STRUCTURAL ENGINEERS REPORT

Addendum report

Wayside
Pexhill
Cronton
Wirral

19-AC-3748a

Photograph 1

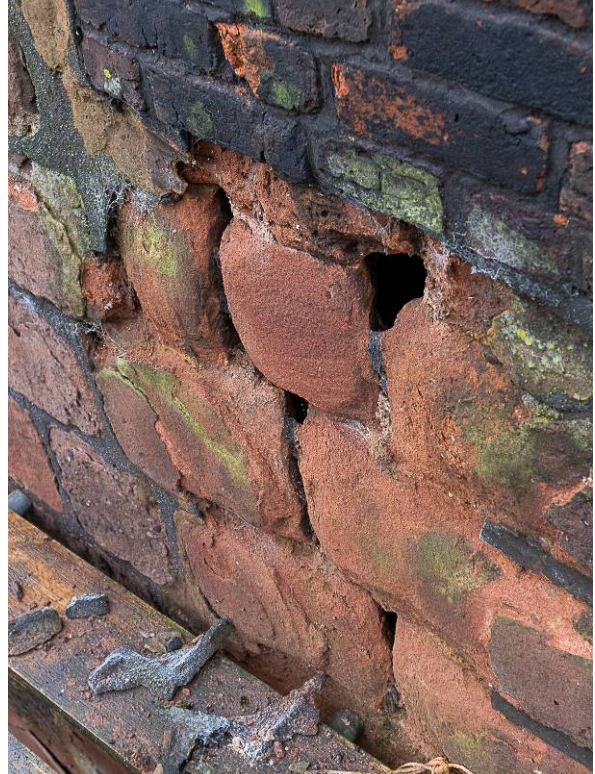
View looking onto the north elevation showing the outward lean of the chimney: the weathered top of the wall and the laterally unrestrained gable pike.

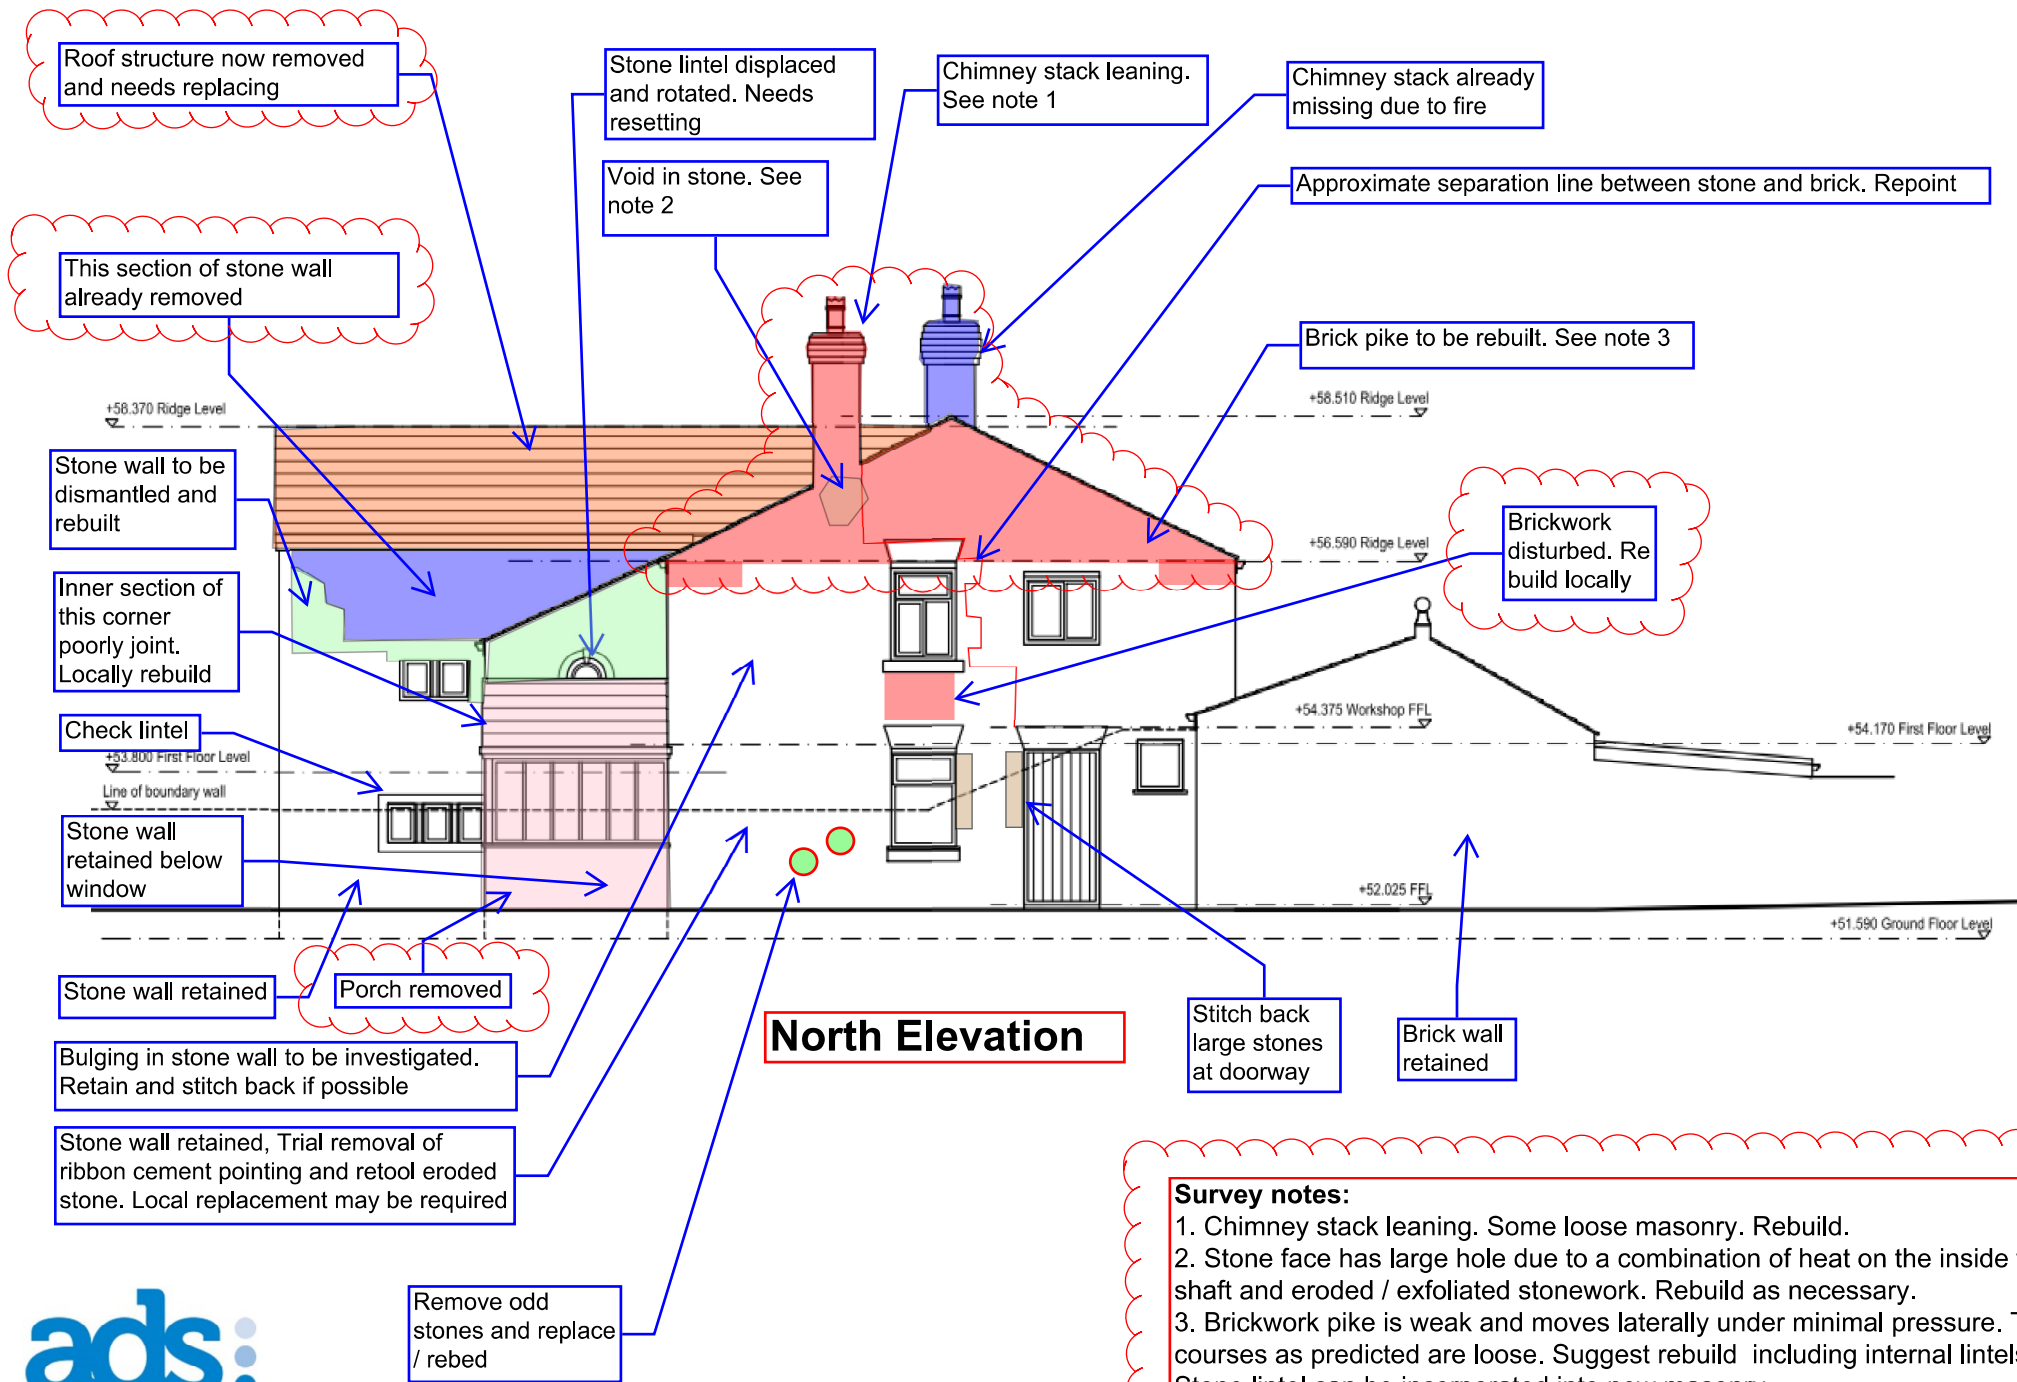
The whole of this stone wall gable is in poor condition and will need many areas of local rebuilding

Lintel out of level and needs resetting. Prop, reset and rebuild masonry over

Chimney stack leaning. See note 1 on SK1

2No diagonal lines of wider joints and crack in stonework. Wall leaning

Stone wall to be dismantled and rebuilt. Confirmed necessary

Check foundation as this appears to have dropped. Possible underpinning required

SK 2 Details of extent of further stone removal and repairs required

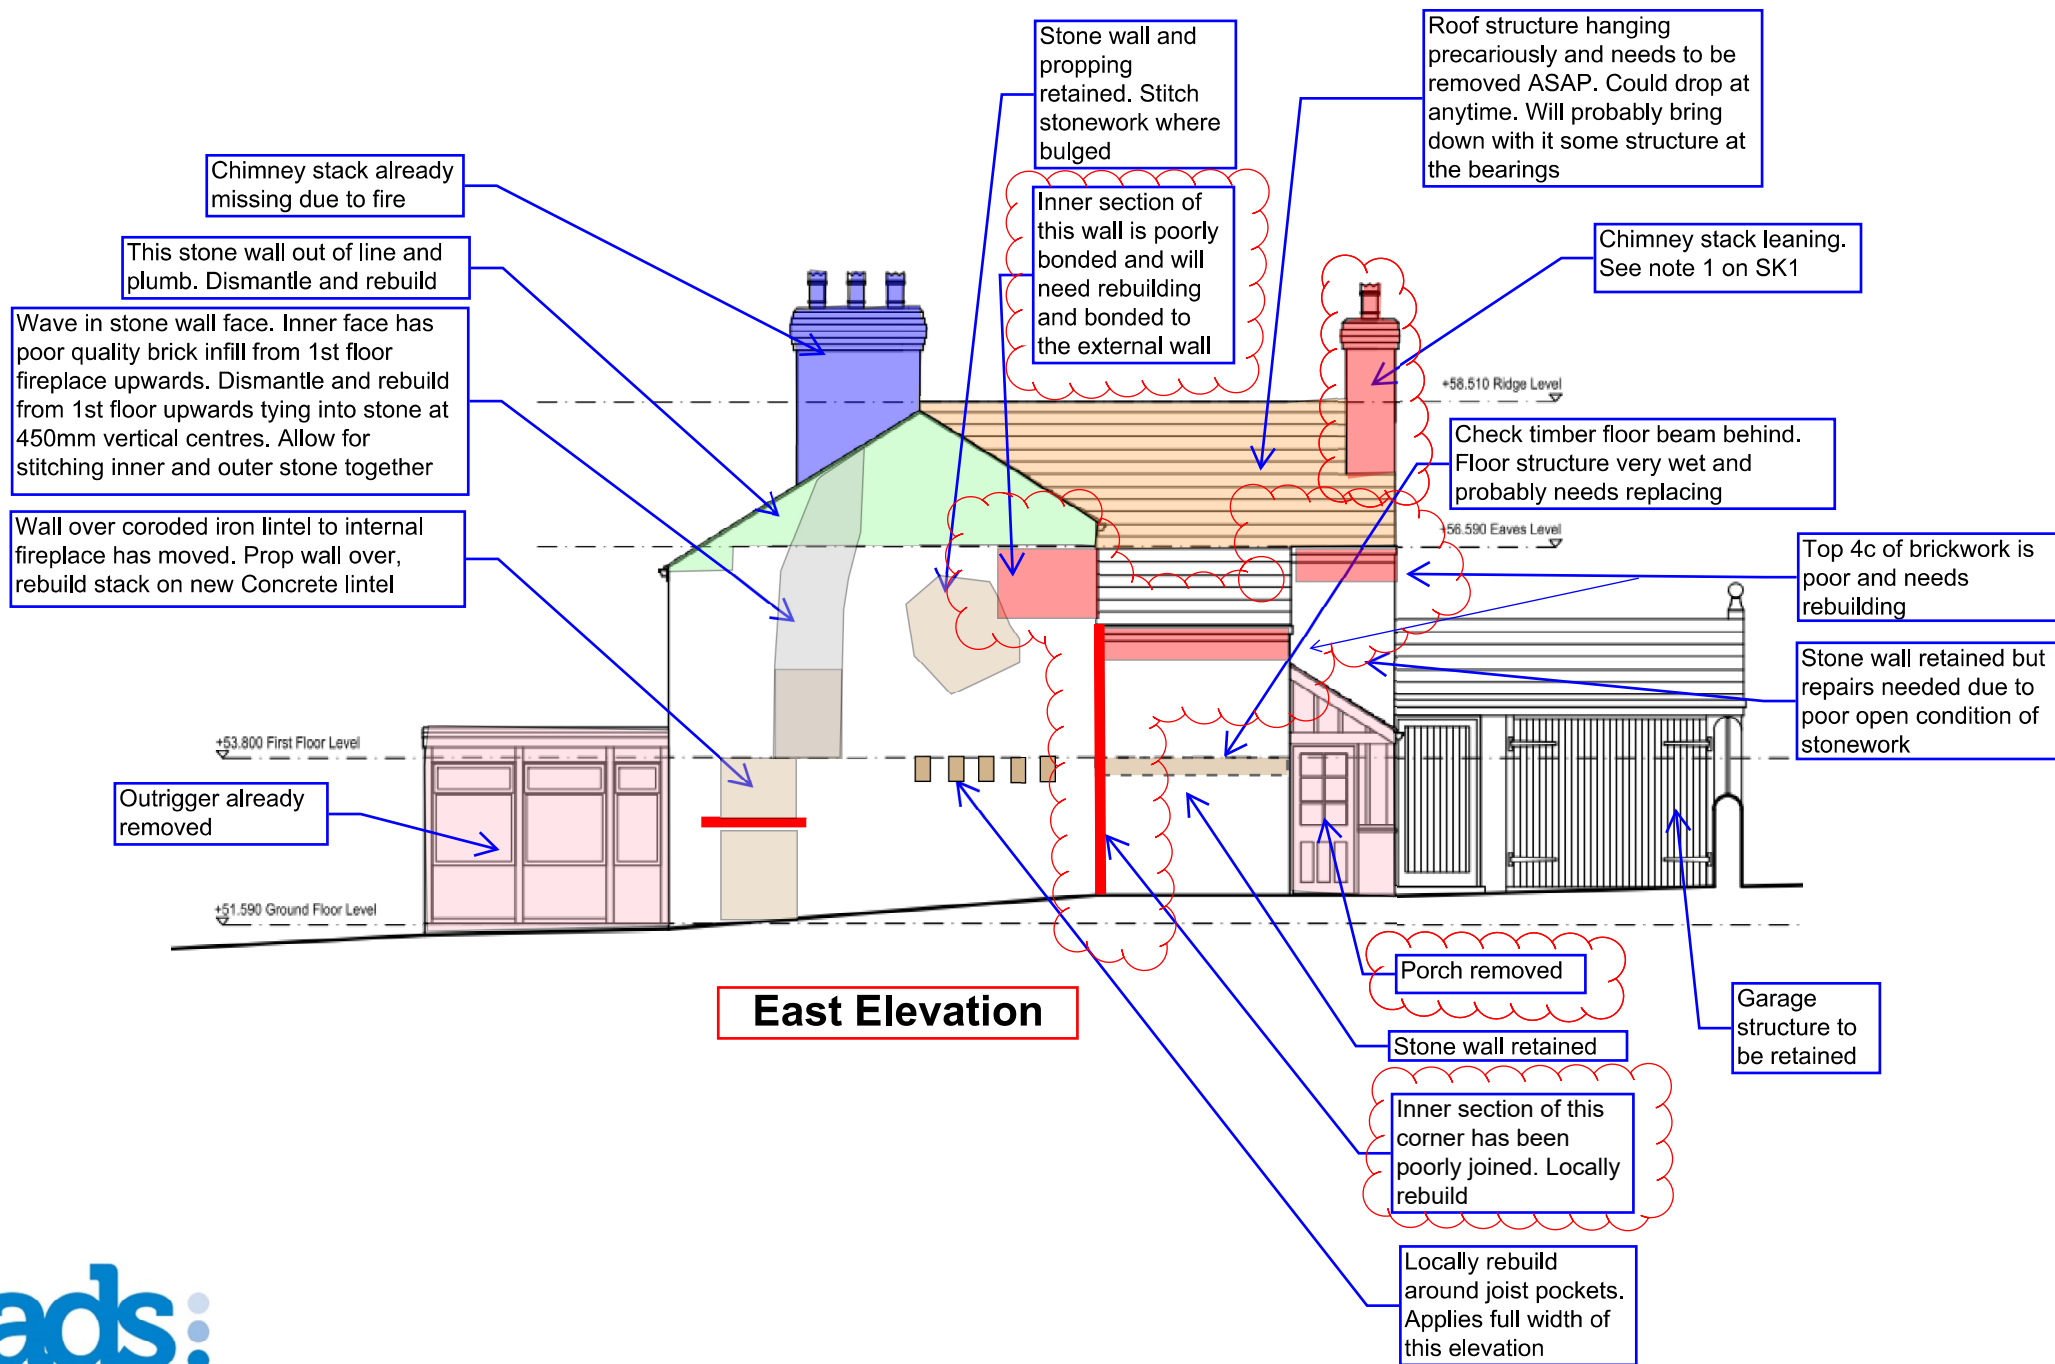
Consider recording and then disassembly of this wall and rebuild on new foundations

Single stone pillar leaning. Take down, check foundation and rebuild

Stitch back large stones at doorway both sides.

Damaged stonework internally. Lintel to be retained due to external carving. Prop lintel, dismantle stone reveal, rebuild lower stonework, reset large upper stone and stitch back to main body of wall

Stone lintel failed and dropped. Needs replacing and front face carved to suit existing. Install new inner lintel and repair stone bearings

External face of wall poor. Remove ribbon cement pointing. Local rebuild and fully repoint.

SK 7 Cross wall details.

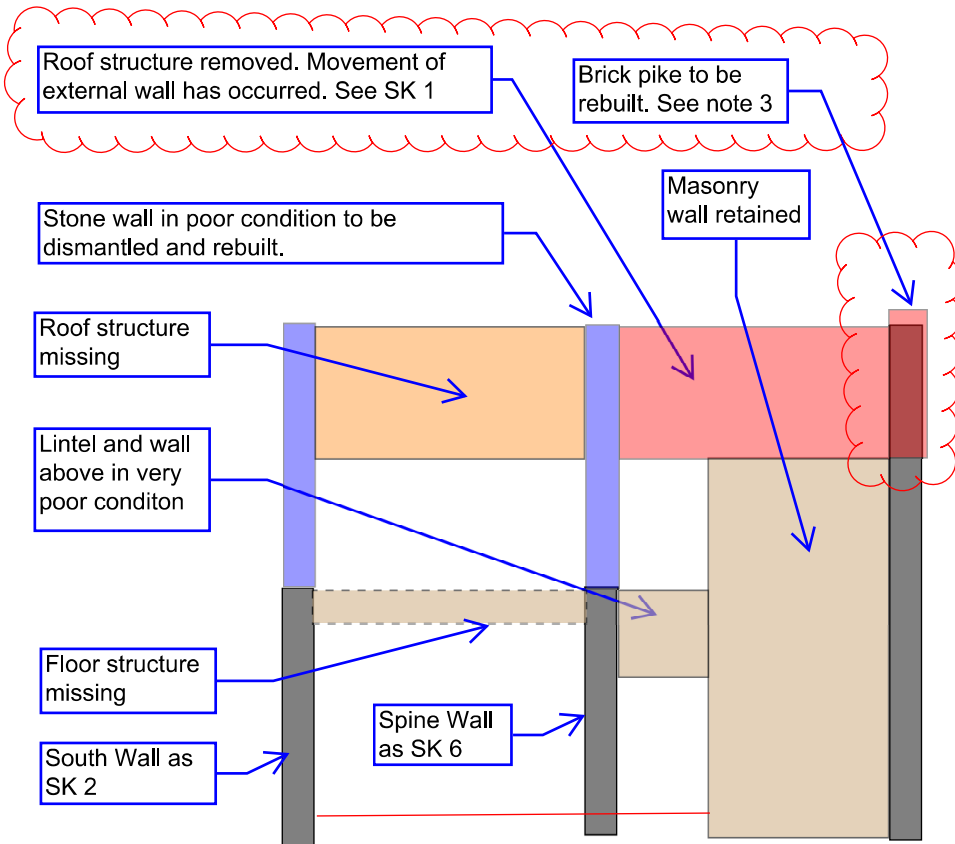
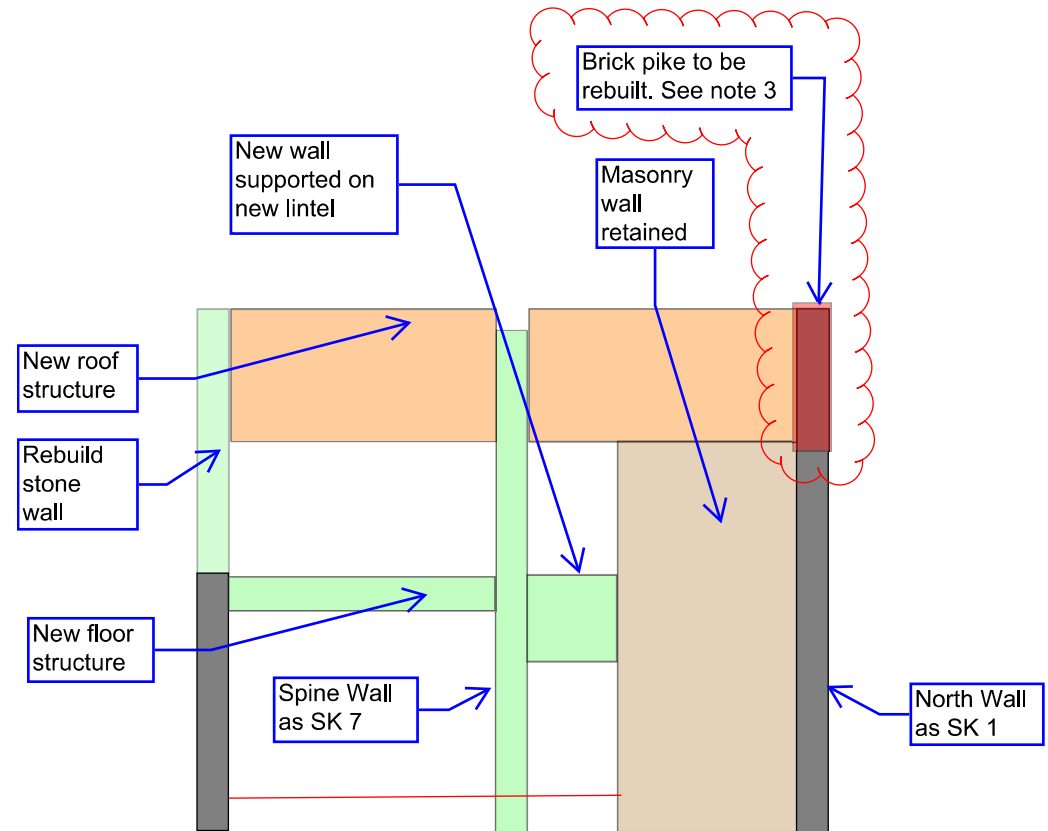
**Cross wall Elevation
Existing condition**

**Proposed cross wall
Elevation**
